Project No. Project Name Associated Cases Council District School District Requested By Deferral Staff Reviewer Staff Recommendation	Subdivision 2003S-238G-12 Highland Creek, Section 6 None 31 - Toler 2 - Blue Holt Valley, LLC, developer, and Anderson-Delk & Associates, Engineer. Deferred from June 24, 2004 Commission Meeting Fuller Disapprove based on the proposed intersection being too close to Nolensville Pike, creating an unsafe intersection.			
APPLICANT REQUEST Preliminary Plat	Subdivide 2.97 acres into 11 single-family lots along the west side of Nolensville Pike, approximately 1,250 feet north of Hills Chapel Road.			
ZONING RS10 District	RS10 district, requiring a minimum lot size of 10,000 square feet and intended for single family dwellings at an overall density of 3.7 dwelling units per acre.			
CLUSTER LOT OPTION	The cluster lot option allows the applicant to reduce minimum lot sizes two base zone districts from the base zone classification of RS10 (minimum 10,000 sq. ft. lots) to RS5 (minimum 5,000 sq. ft. lots). Pursuant to Section 17.12.080(D) of the Metro Zoning Ordinance, cluster lot subdivisions require a minimum of 15% open space per phase. The applicant complie

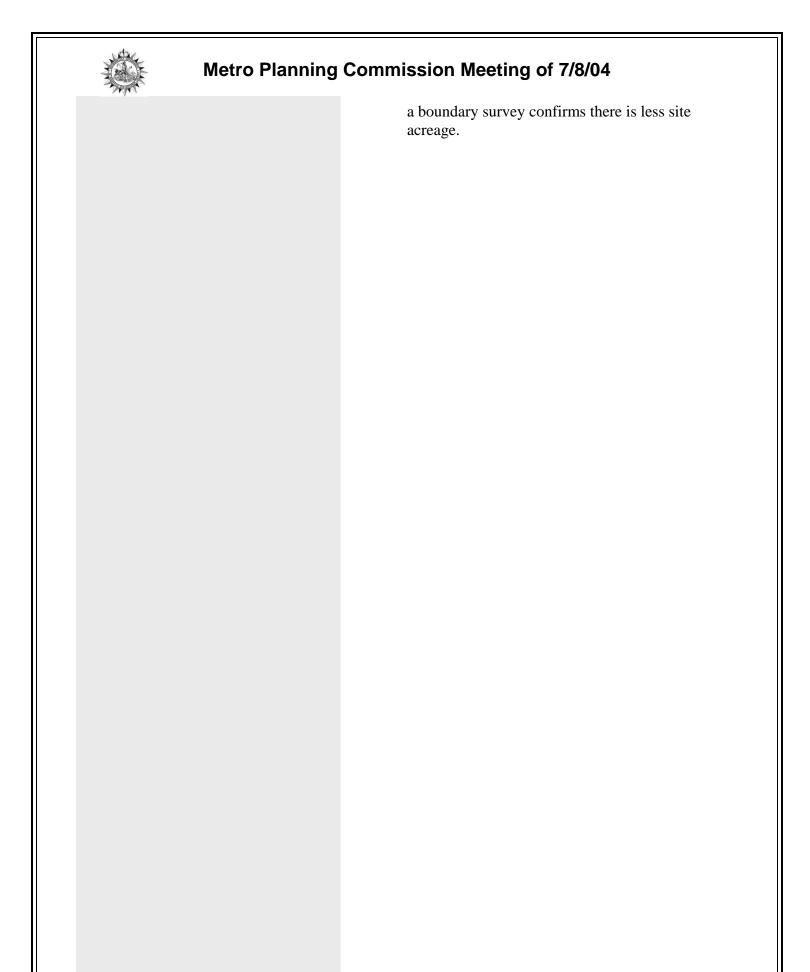
- 1. Label right of way width and distance to centerline.
- 2. Submit trip generation comparison between existing, approved land use and daycare.
- 3. Preliminary comments include driveways are not compliant with regulations. Additional median cuts will not be granted. Locate distance between driveways and intersections and locate driveways on opposite side of Marriott Drive.
